Report Date:October 10, 2018 File:107664

Report Number:099541

Re: Non-compliance Advisory Letter, Permit 107664, 1810 Verling Ave, Saanichton BC V8M 1X6, Air

Photo 2. Ventilation inlet with mesh screen in place.

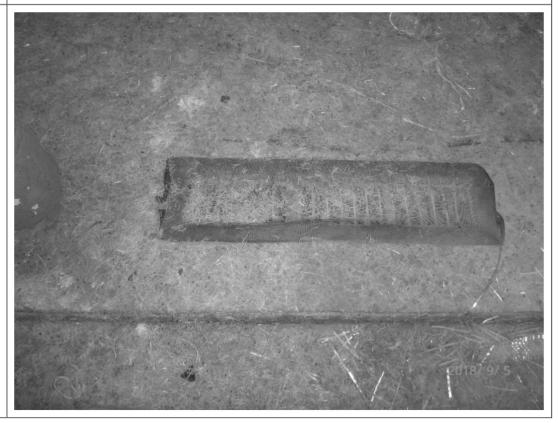
Compliance:	In
Requirement Description:	2.1 Authorized Works
	2.1.1: The Permittee must ensure that inlet mesh screens are in place during operations, where required in Section 1.
Details/Findings:	During the inspection, Officer Wheating observed that some of the ventilation system inlets did not have mesh screens in place (Photos 1 to 4).
Compliance:	Out
Actions to be taken:	Ensure that all ventilation systems inlets have mesh screens in place during operation.
Requirement Description:	2.1 Authorized Works

Photo 3.

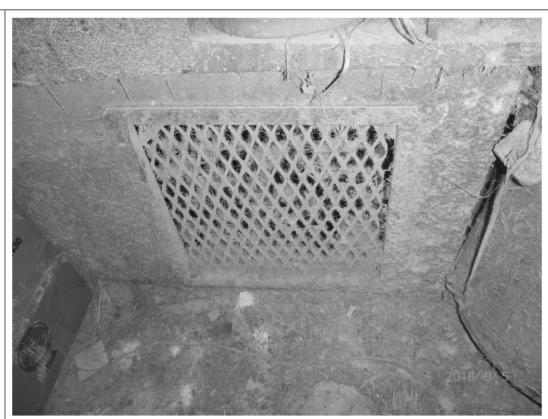
Ventilation inlet without mesh screen in place.
